**SUBDIVISION &
REZONING STAFF REPORT****Date: December 17, 2020**

<u>NAME</u>	Cypress Business Park Logistics Subdivision
<u>LOCATION</u>	4583 Cypress Business Park Drive (West side of Cypress Business Park Drive, extending to the East side of Interstate 10)
<u>CITY COUNCIL DISTRICT</u>	District 4
<u>PRESENT ZONING</u>	B-3, Community Business and B-5, Office-Distribution
<u>PROPOSED ZONING</u>	B-5, Office Distribution District
<u>AREA OF PROPERTY</u>	45.2 ± Acres / 3 lots
<u>CONTEMPLATED USE</u>	Subdivision approval to create three (3) legal lots of record and Rezoning from B-3, Community Business District and B-5 Office Distribution District to B-5, Office Distribution District
<u>TIME SCHEDULE FOR DEVELOPMENT:</u>	Immediately
<u>ENGINEERING COMMENTS:</u>

DETAIL SITE PLAN

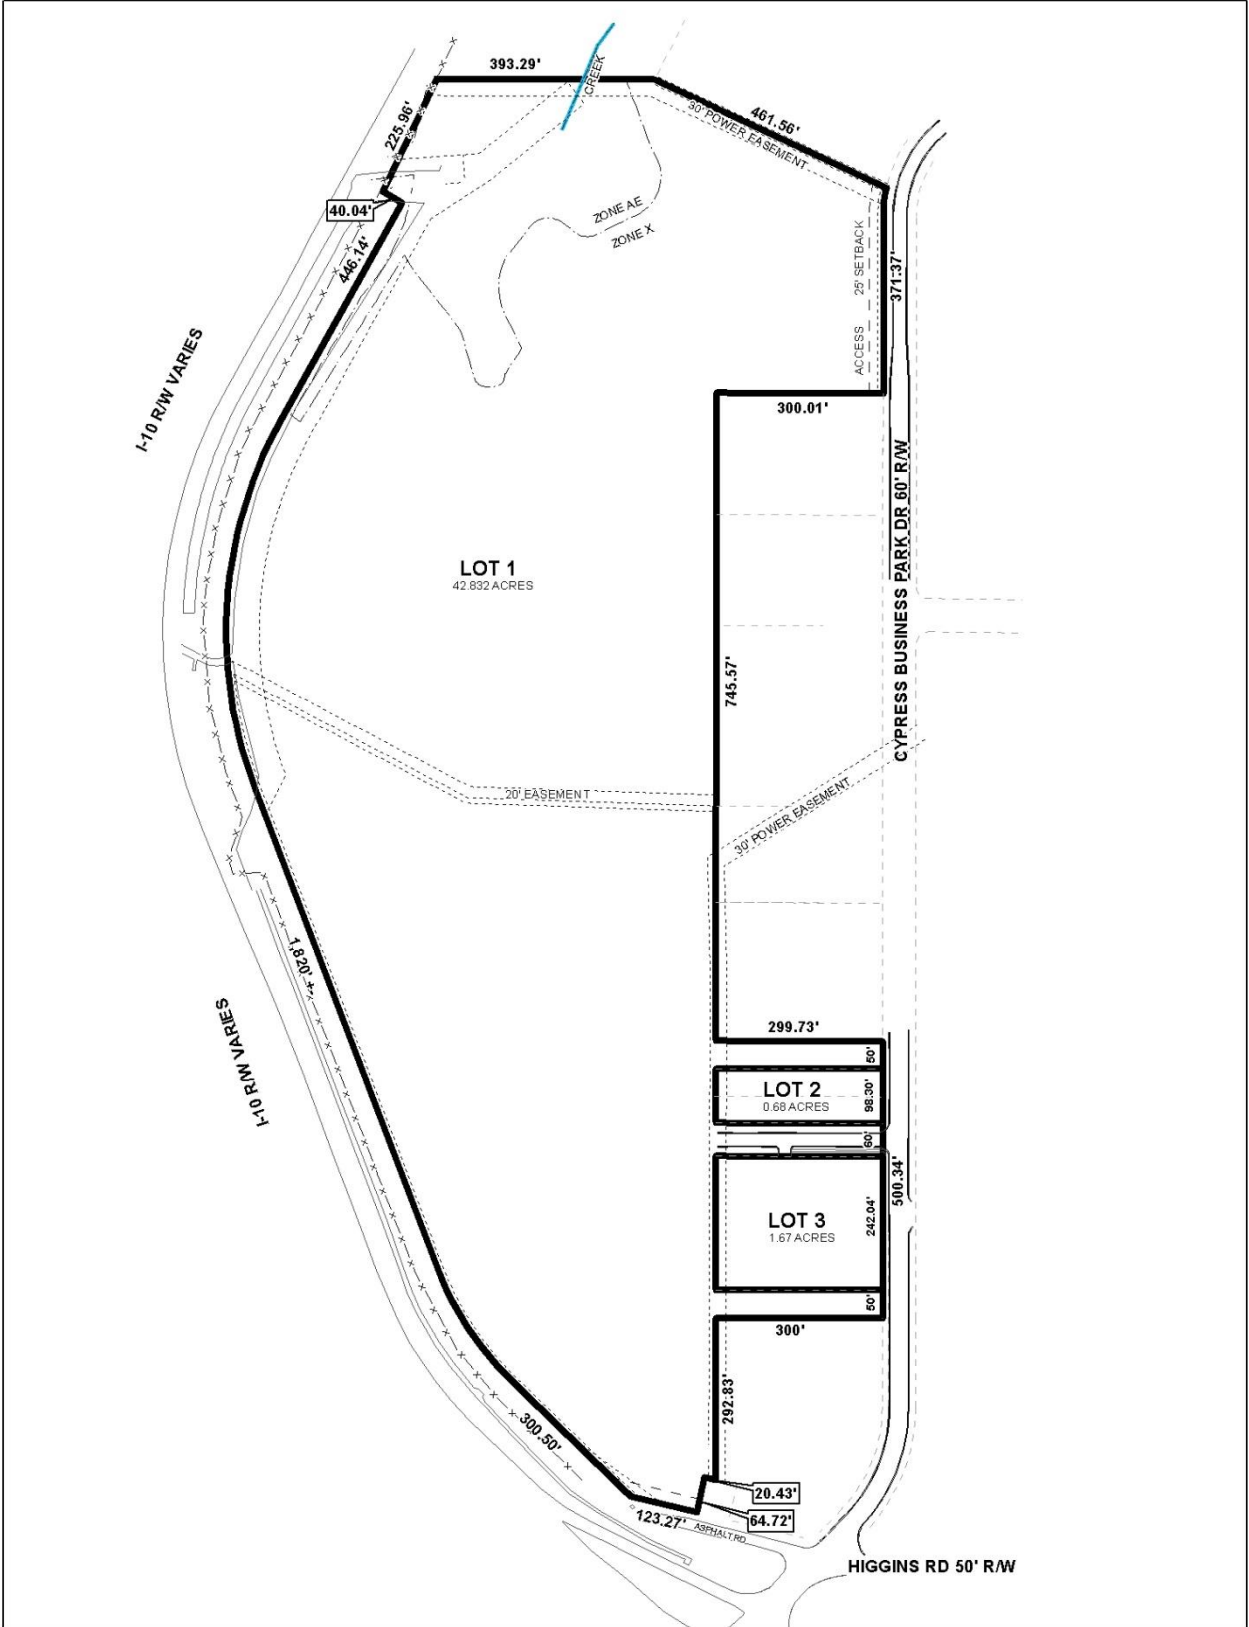
Regarding the subdivision plat submitted, subdivision note #2 states "No further resubdivision of the Lot is allowed until frontage on a roadway meeting city standards is provided." Most likely, this was a note on a prior plat when a large lot had only a small amount of frontage on Cypress Business Park Drive; as proposed all lots have extensive street frontage this note is no longer applicable.

It should be noted that a sidewalk is not illustrated along Cypress Business Park Drive. If a sidewalk is not to be provided, a sidewalk waiver approved by the Planning Commission would be required.
